HSXS-PVM (20 Jun 83) 2d Ind
SUBJECT: Radiation Protection Survey No. 28-43-0705-83, MEDDAC/DENTAC,
Fort Monmouth, New Jersey, 14-16 March 1983

SUBJECT: Radiation Protection Survey No. 28-43-0705-83, MEDDAC/DENTAC, Fort Monmouth, New Jersey, 14-16 March 1983

ANALYSIS OF DIAGNOSTIC X-RAY UNITS SURVEYED

Rad-Fluoro Room 1, PACH

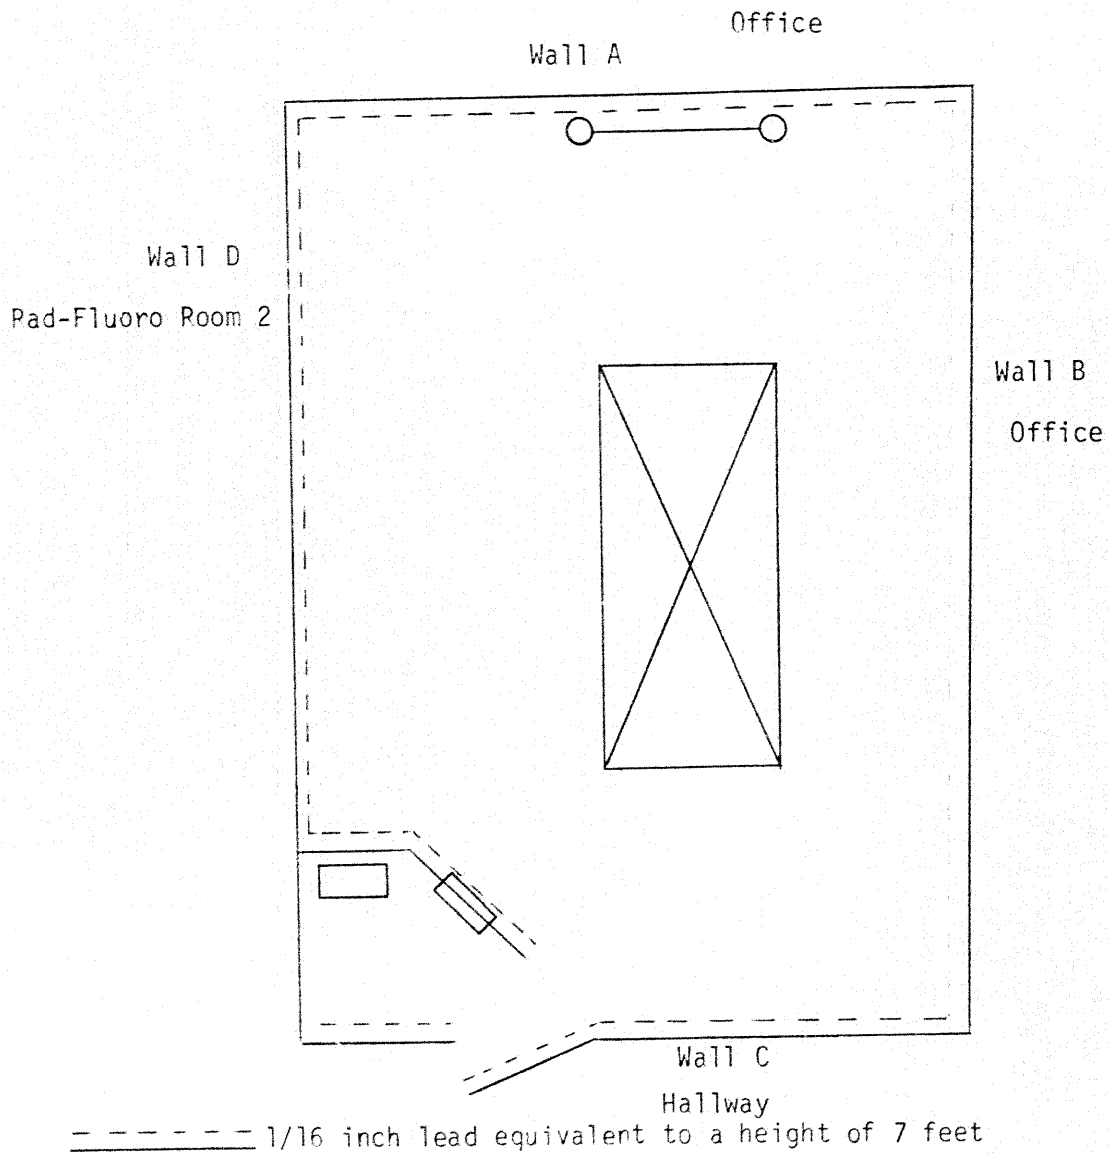
2. DESCRIPTION OF DEFICIENCIES. The system could not be operated manually
in the fluoroscopic mode.

4. CORRECTIVE REQUIREMENTS. Repair the fluoroscopic mode controls so that
the system can be controlled manually.

(1) Deficiency: The system could not be operated manually in the fluoroscopic mode.

(2) Corrective Action: The broken wire in the cable has been repaired so that the system can be controlled manually.

Rad-Fluoro Room 2, PACH

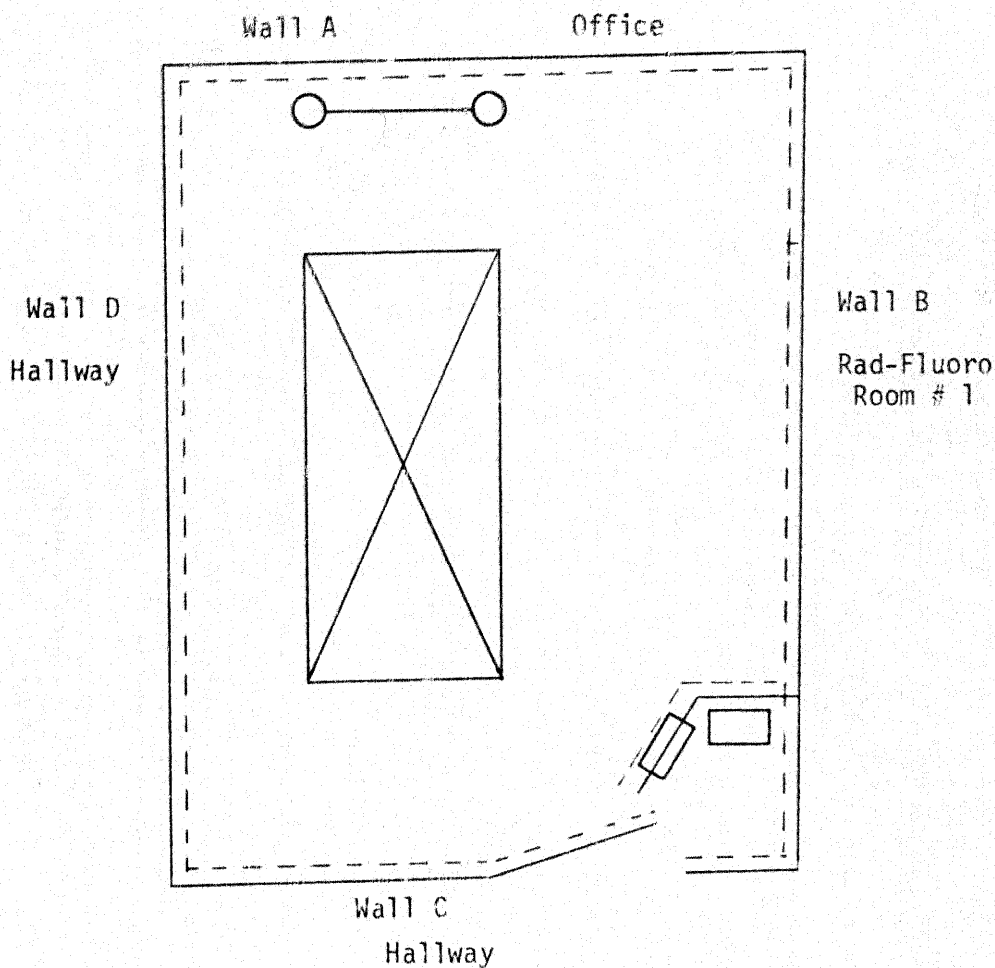
2. DESCRIPTION OF DEFICIENCIES. The maximum fluoroscopic output rate of
10.7 R/min is greater than the allowable standard of 10 R/min.

3. COMMENTS. The NCOIC of the Radiology Department was informed about this
deficiency. He stated that the 120 kVp station was seldom used and that it
could be disabled. The rate of 10.7 R/min was obtained using the maximum kVp
available from the system.

4. CORRECTIVE REQUIREMENTS. Disable the 120 kVp station, reduce the maximum
available tube current or make other repair/adjustments so that the maximum
fluoroscopic output does not exceed 10 R/min for any combination of peak tube
potential and tube current in accordance with paragraph 5-2b(1), TB MED 521.

(1) Deficiency: Maximum fluoroscopic output rate of 10.7 R/min is greater than the allowable standard of 10 R/min.

(2) Corrective Action: The 120 kVp station was disabled and adjustments were made to reduce the maximum fluoroscopic output so it does not exceed 10 R/min for any combination of peak tube potential and tube current.

Dental Unit, Room 1A96, PACH

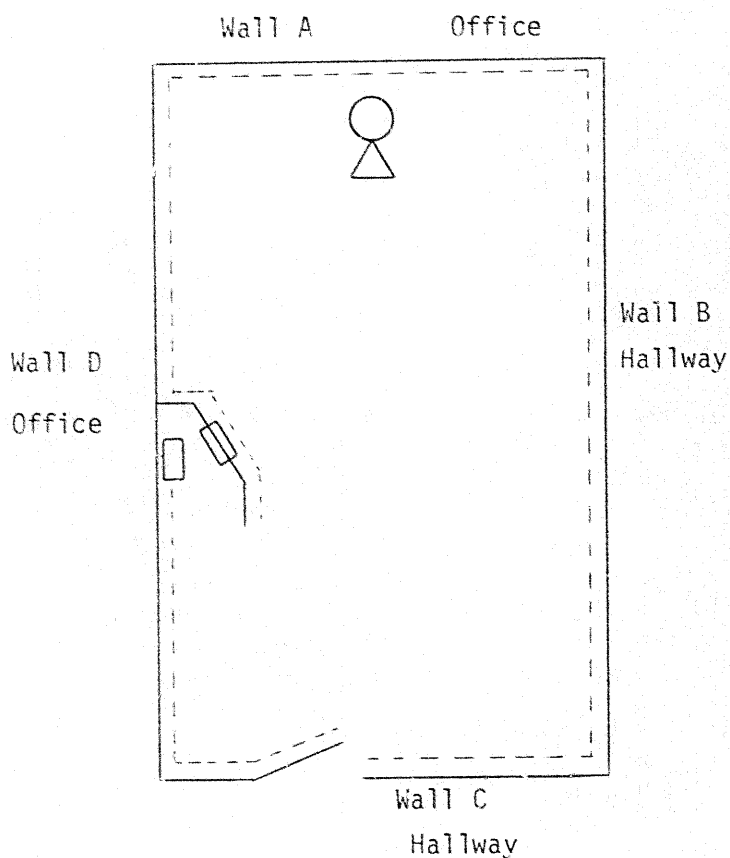
a. The kVp was out of calibration. An indication of 90 kVp on the control console corresponded to a measured kVp of 54.8.

b. The HVL of the beam was about 1.6 mm Al. This HVL in conjunction with a measured kVp of 54.8 indicates a total filtration in the beam of approximately 2.0 mm Al. Units designed to operate at 90 kVp should have at least 2.5 mm Al total filtration in the beam.

4. CORRECTIVE REQUIREMENTS. Discontinue use of this unit until extra filtration is placed in the beam and the kVp output is properly adjusted in accordance with paragraphs 5-6a(4) and 5-6b(5), TB MED 521.

(1) Deficiency: The kVp was out of calibration and decreased filtration in the beam.

(2) Corrective Action: Extra filtration was placed in the beam and the kVp output was properly calibrated.

Dental Clinic, Building 814, Fort Monmouth, New Jersey

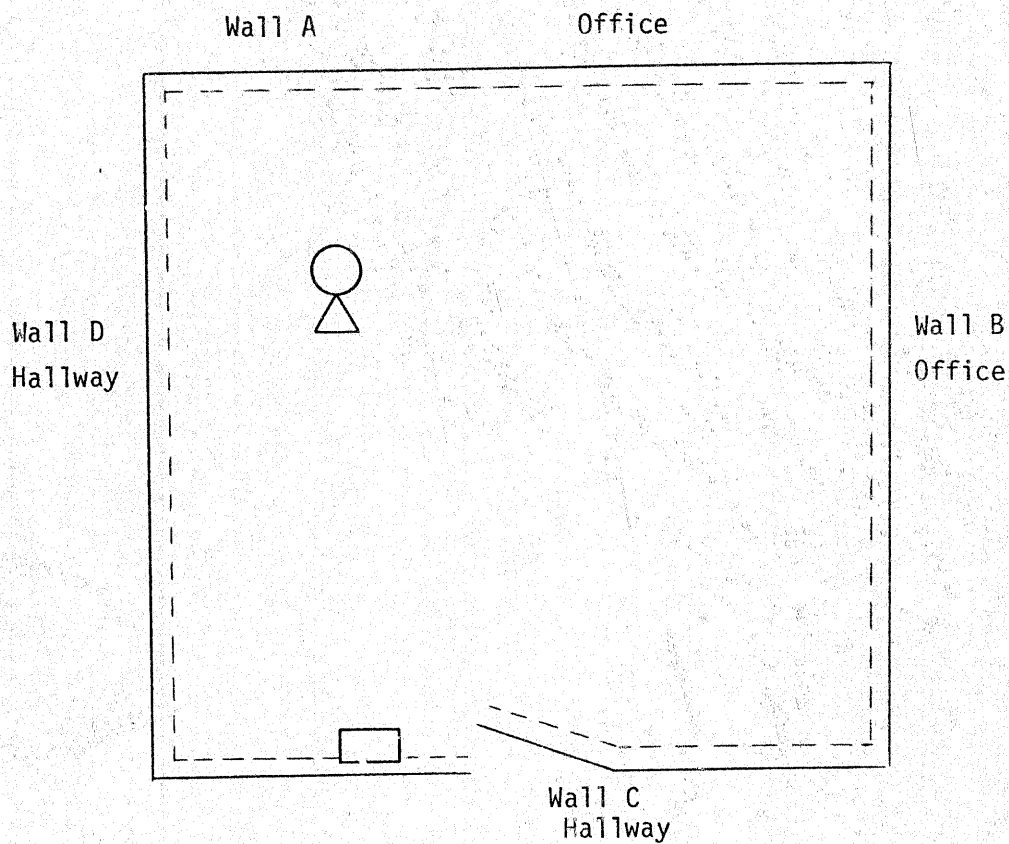
3. COMMENTS. The kVp output of the generator could be caused to operate beyond the manufacturer's specifications. This could be accomplished by turning the line voltage compensator knob until the dial indicator was no longer in the "white" operating area. The manufacturer's operating instructions recommended not operating the unit when the dial indicator was outside of the "white region." Operating personnel should be informed of the importance of this easily alterable adjustment.
